# THE VILLAGES OF LAKE BOONE TRAIL S-50-2014

# Administrative Approval Action

The Villages of Lake Boone Trail (Sunset Extension): S-50-14, AA# 3814
Transaction# 551024, Original Transaction# 412776, Original AA#3262

# PRELIMINARY SUBDIVISION SUNSET EXTENSION AND REVISION

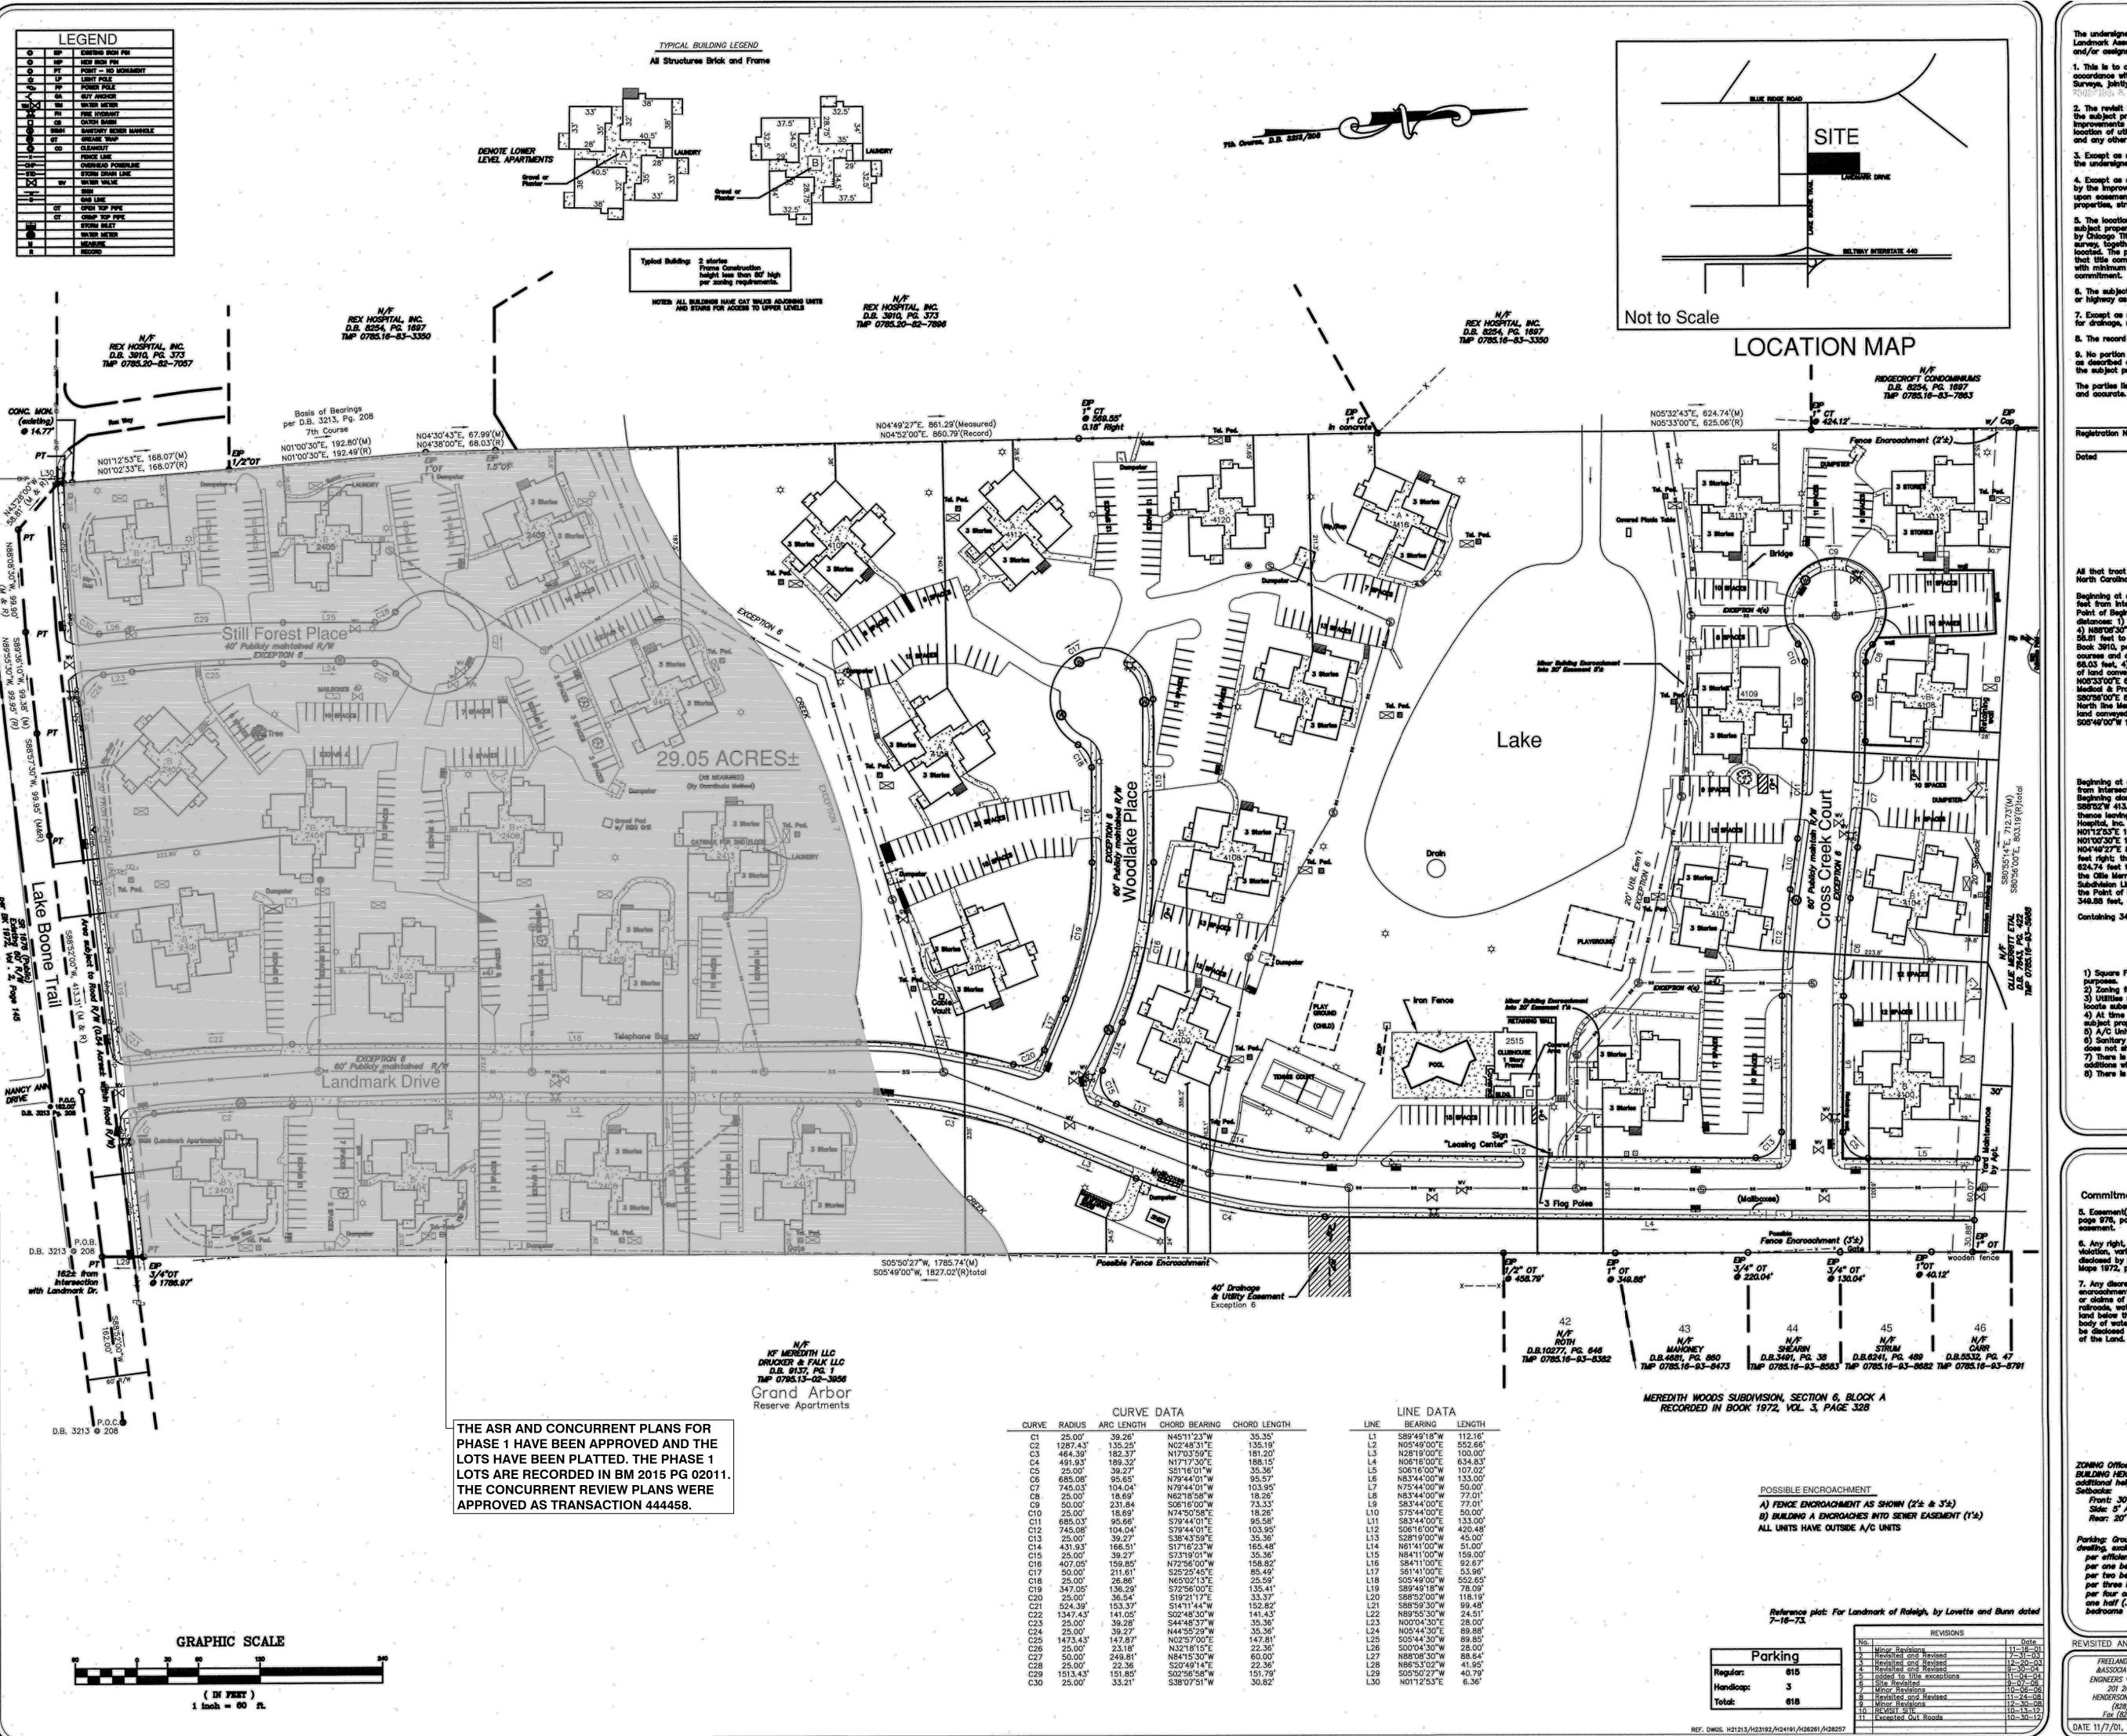
SUMMARY OF SUBDIVISION PLAN REVISIONS FOR SUNSET DATE EXTENSION:

2. SHEET C-0 WAS ADDED TO SET WITH ZONING CONDITIONS AND SUMMARY OF COMPLIANCE FOR EACH CONDITION.

3. THE ORIGINAL SUBDIVISION PLAN INCLUDED THREE PHASES. THE ASR AND CONCURRENT PLANS FOR PHASE 1 HAVE BEEN APPROVED AND THE LOTS HAVE BEEN PLATTED; CONSEQUENTLY, THE PHASE 1 AREA WAS SHADED AND A NOTE CONCERNING THE PHASE 1 AREA WAS ADDED TO ALL APPLICABLE SHEETS. THE PHASE 1 LOTS ARE RECORDED IN BOOK 2015, PAGE 02011.

4. THE ORIGINAL SUBDIVISION PLAN INCLUDED 12 LOTS. THE PLAN WAS REVISED TO INCLUDE A TOTAL OF 10 LOTS ON ALL APPLICABLE SHEETS. THE FOLLOWING SUMMARIZES THE REVISIONS:

a. LOTS 7 AND 8 WERE COMBINED TO CREATE A SINGLE LOT. THE LOT REFERENCE IS LOT 7.
b. LOTS 10 AND 11 WERE COMBINED TO CREATE A SINGLE LOT. THE LOT REFERENCE IS LOT 11.

c. THE PHASE 1 LOT AREAS WERE REVISED TO BE CONSISTENT WITH THE RECORDED LOT AREAS. THE SQUARE FOOTAGE FOR EACH LOT HAS BEEN PROVIDED.
 d. THE PHASE 2 AND 3 LOT AREAS WERE REVISED TO REFLECT UPDATED AREAS

BASED ON LOT RECOMBINATION AND BNK SURVEYING. THE SQUARE FOOTAGE FOR EACH LOT HAS BEEN PROVIDED.

e. THE SITE DATA TABLE ON SHEET C-4 WAS REVISED TO REFLECT THE REVISED

5. A DIMENSION WAS ADDED TO LOT 12 SHOWING A MINIMUM WIDTH EXCEEDING 50-FEET TO REFLECT CONFORMANCE WITH THE OPEN LOT STANDARDS.
6. ADDITIONAL INFORMATION WAS INCLUDED ON THE APPLICABLE SHEETS TO

LOT AREAS AND RECOMBINATION OF LOTS 7/8 AND 10/11.

DISTINQUISH THE LOT LINES, PHASE LINES AND ZONING LINES.

7. THE TREE CONSERVATION AREAS FOR THE OVERALL SUBDIVISION HAS BEEN RECORDED. A NOTE WAS ADDED TO THE COVER SHEET AND SHEET TC-1 WITH THE RECORD PLAT INFORMATION.

A 20' PEDESTRIAN ACCESS EASEMENT WAS ADDED ON THE SOUTH SIDE OF LOT 7 (PHASE 2) FOR A FUTURE PEDESTRIAN CONNECTION TO LOT 5 (PHASE 1) PER CITY REQUEST. REFER TO SHEET C-0 FOR LIST OF ZONING CONDITIONS AND SUMMARY OF ZONING CONDITIONS COMPLIANCE
